## CHANGE NOTIFICATION

PCN# 051315

### **Subject: Notification of Additional Assembly Location, ASE Korea for LTM8025**

Country of Origin on Top Mark

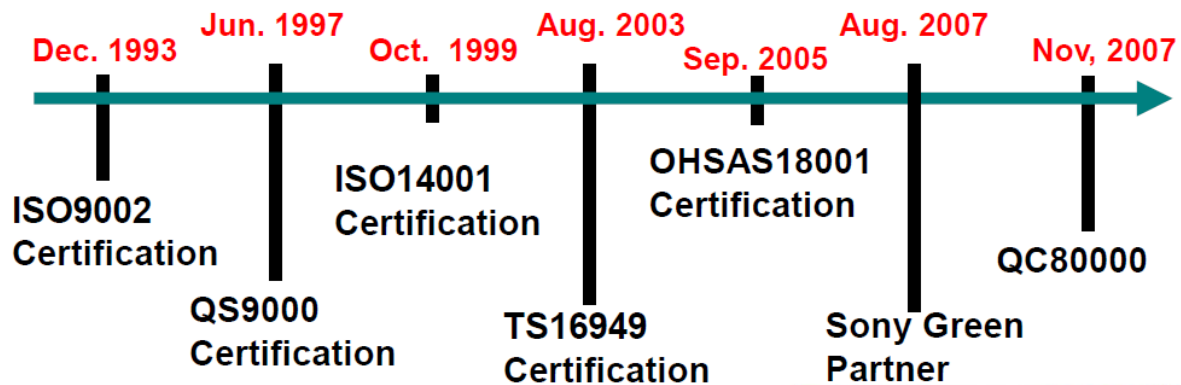
Please be advised that Linear Technology Corporation has successfully qualified ASE Korea as an assembly site for the subject packages. It was desirable to qualify ASE Korea to serve as an alternate source since it is located in a different geographic area than our existing assembly location in Penang, Malaysia. ASE Korea is ISO9002, QS9000, ISO14001, TS16949, OHSAS 18001 and QC80000 certified. A summary of ASE Korea's product mix and LTC's qualification results are shown on the attached pages. The facility passed a site audit by LTC's supplier quality organization. LTC product assembled in ASE Korea can be identified by the country of origin marked on the device as "KR". The product photo showing the ASE Korea marking is attached. The Approximate datecode of the first units assembled by ASE Korea, and the list of affected part numbers is presented below in the table.
